Addendum Number Five
To The Drawings and Specifications for
EMS Post #1
RFB Bid Number: 26-0035, Sedgwick County, Kansas

Issued: September 22, 2026

You are hereby instructed to include in your bids the following changes and/or corrections to the Drawings and Specifications for the **Construction of the New EMS Post #1 – 3099 W. 13th Street North, Wichita, Kansas 67203.**

SHEET
A4.1
OF 1 SHEETS

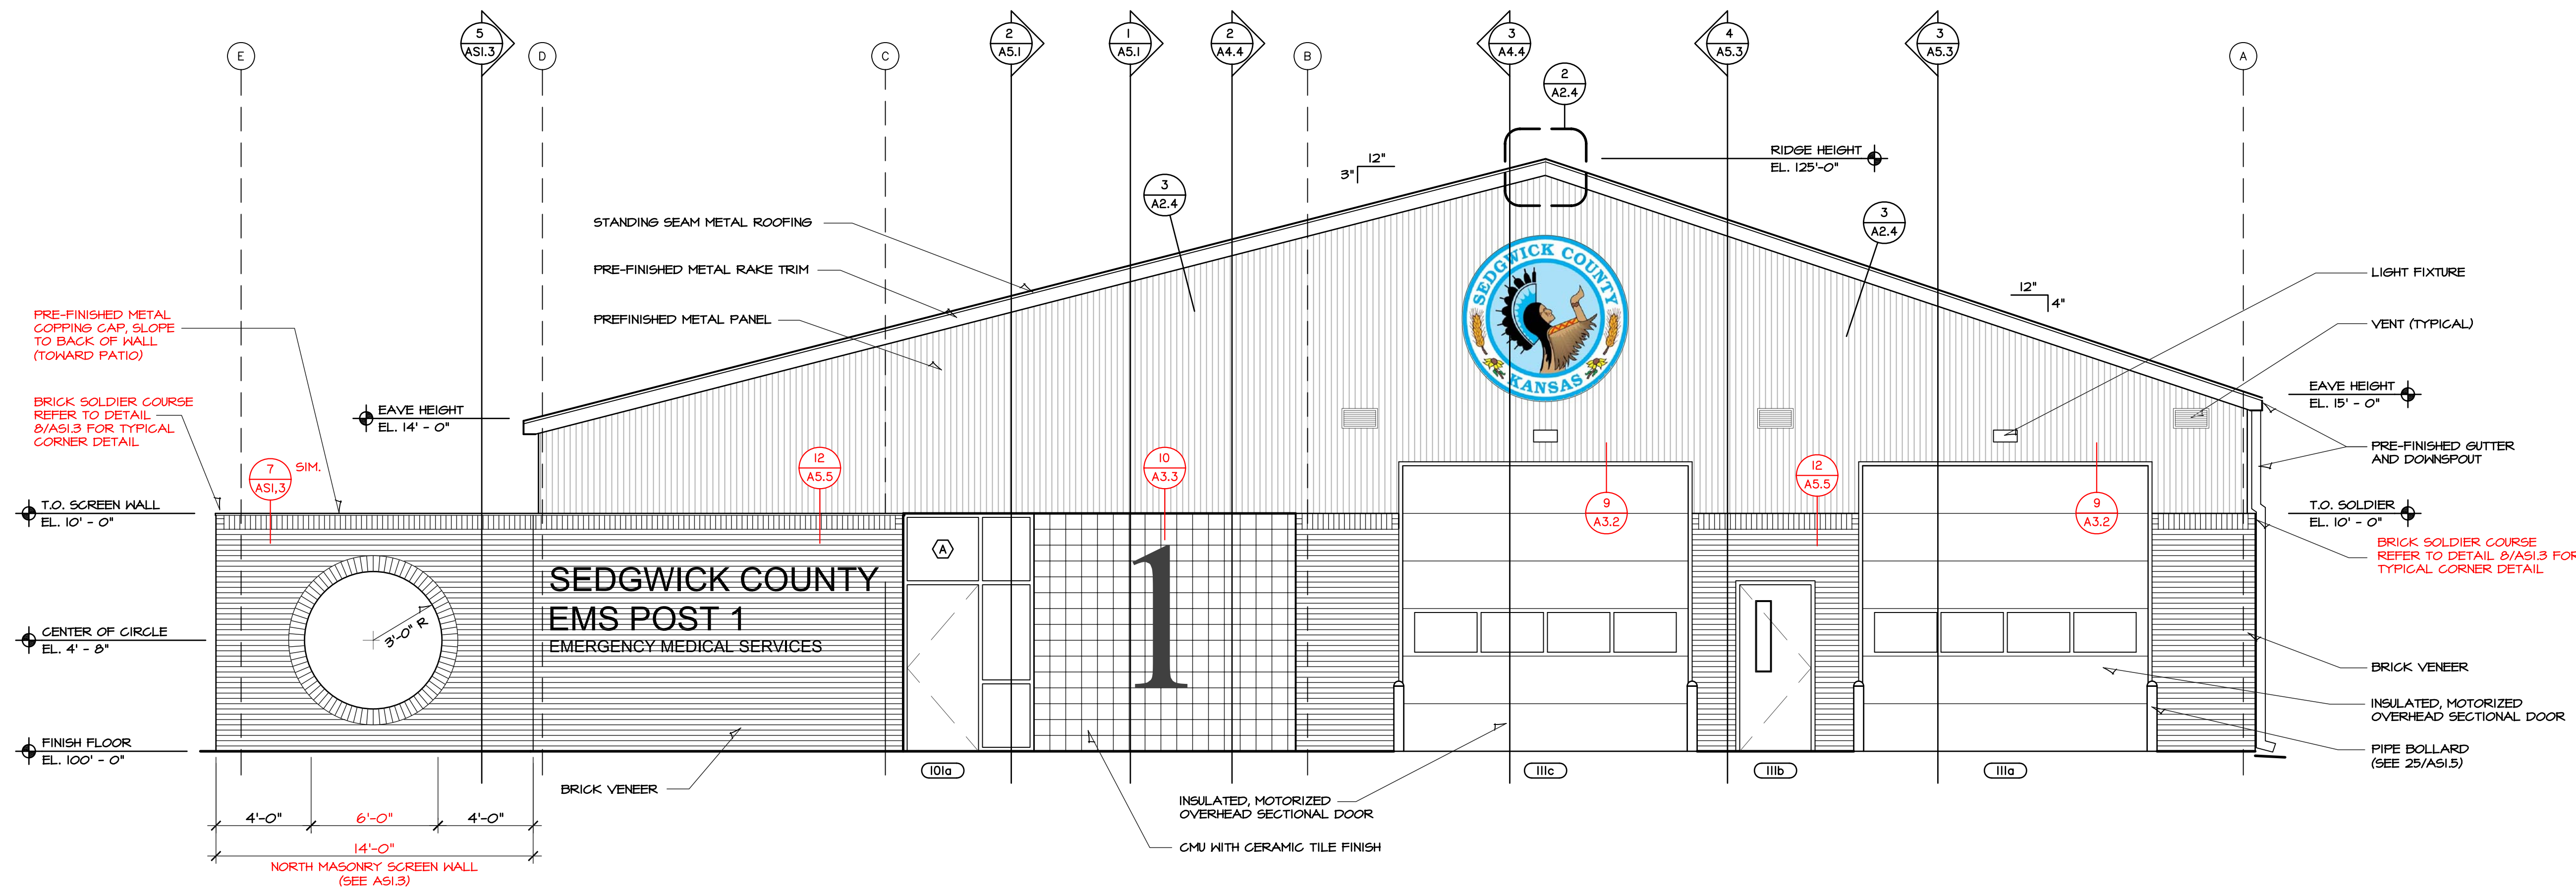
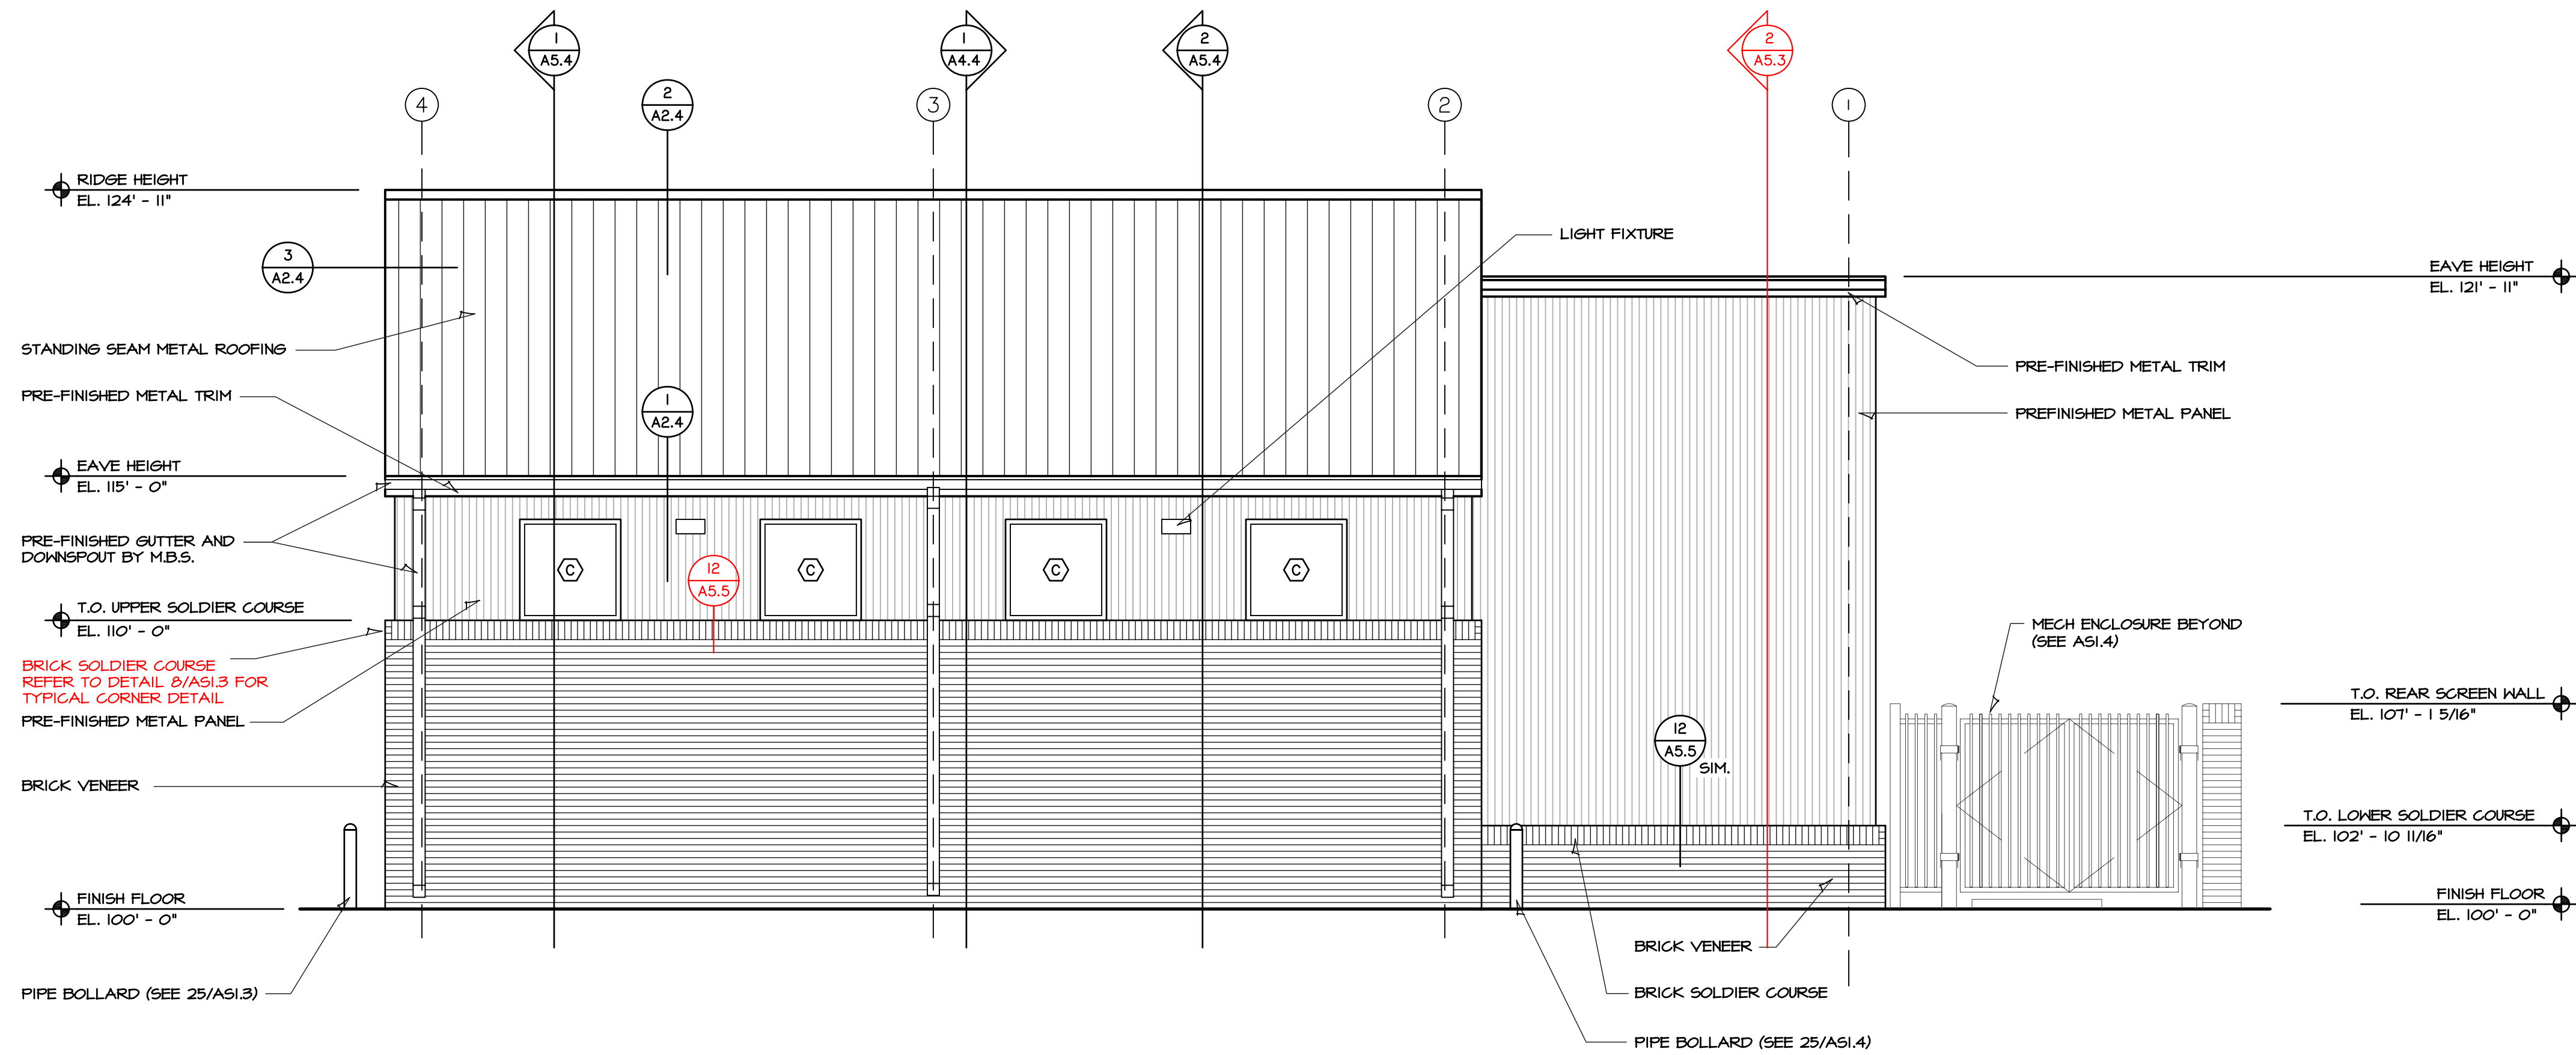
- 5. The blue/Ocean color tile application is the full exterior north wall of the entry recess as shown on Elevation A on sheet A4.1. The tile then extends into the building from the entry door to the kitchen. The tile then turns back to the west as a tile wainscot between the counter top to the bottom of the upper cabinets. Refer to the Floor Plan on Sheet A1.1, there is a dashed line that indicates the tile wall. The tile is also on the pony wall as a backslash. Refer to Elevations 1, 2 and 4 on Sheet A6.2
